July 22, 2019

On behalf of the Willkommen Development Team please see the enclosed materials for updates to the original Willkommen package originally submitted May 25th, 2019.

Willkommen Density and Development Requirements Responses (7/22/19)

1619 RACE STREET- ROOFS

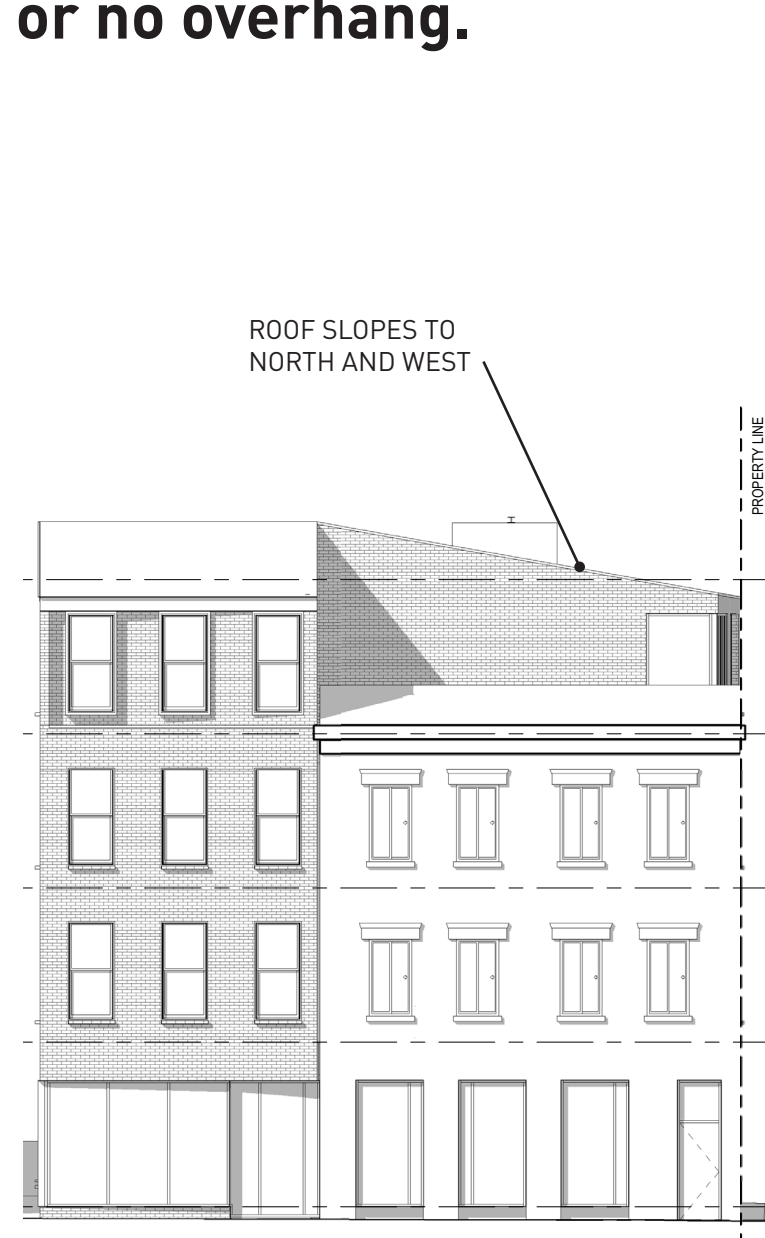
UNCOVER EXISTING CORNICE AT EXISTING HISTORIC BUILDING AND RESTORE

1619 RACE STREET- RHYTHM AND VERTICAL EMPHASIS

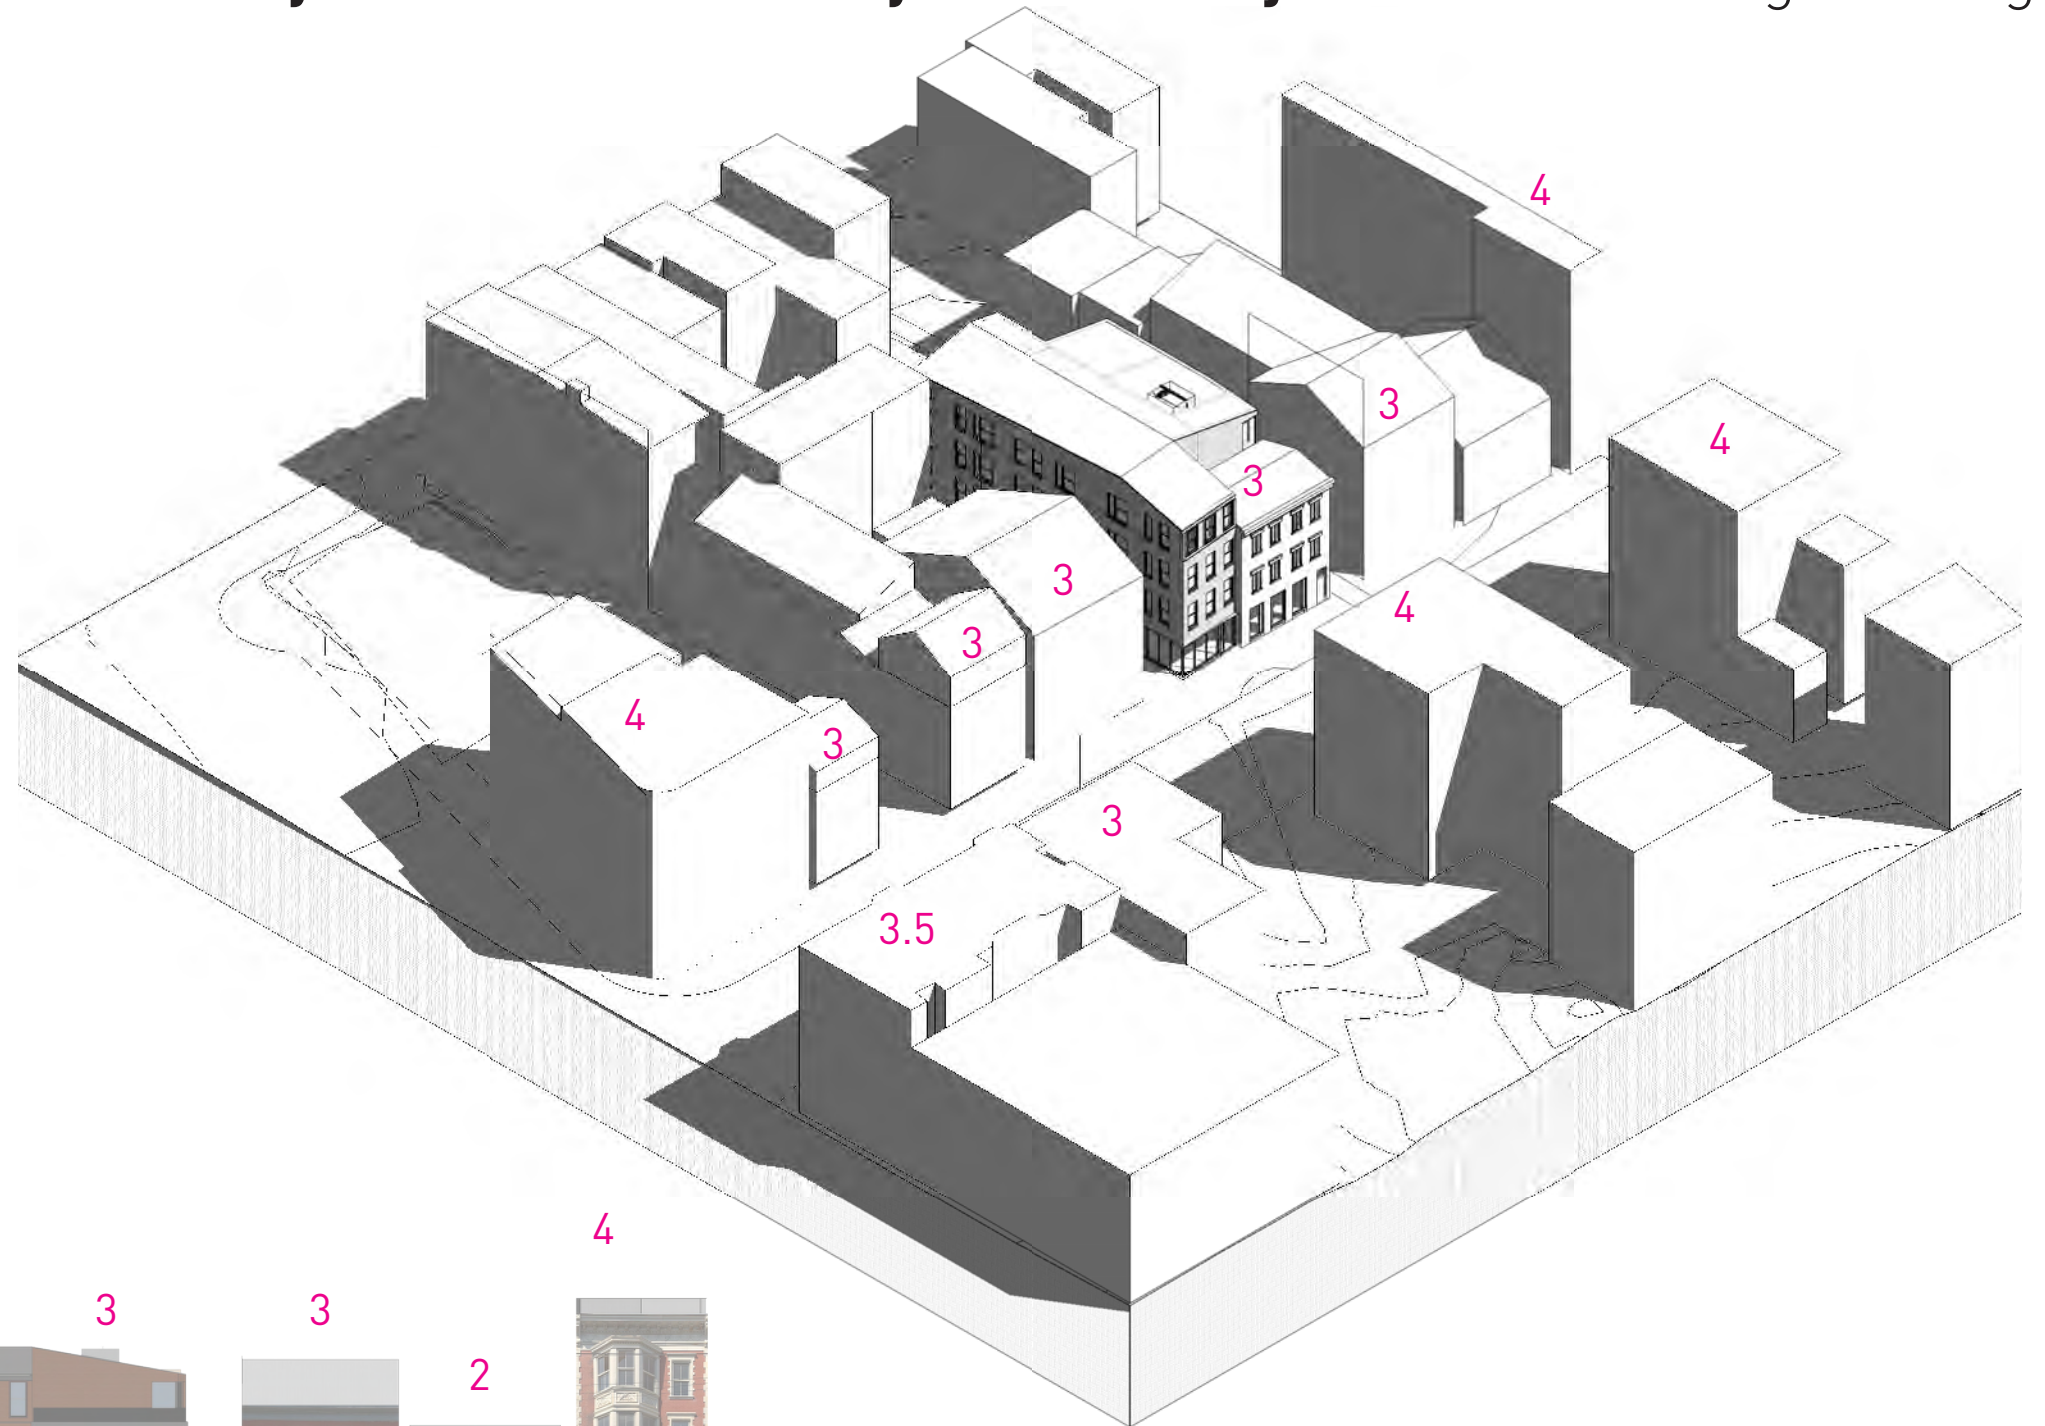
THE CORNICE LINE IS DROPPED TO THE TOP OF WINDOW TO HELP BRING DOWN THE PERCEIVED HEIGHT SO THAT IT APPEARS TO BE BETWEEN THE HEIGHTS OF THE 3 AND 4 STORY BUILDINGS. THE BULK OF THIS BUILDING IS WELL BEHIND THE EXISTING HISTORIC BUILDING TO THE NORTH AND SHOULD NOT BE VERY VISIBLE.
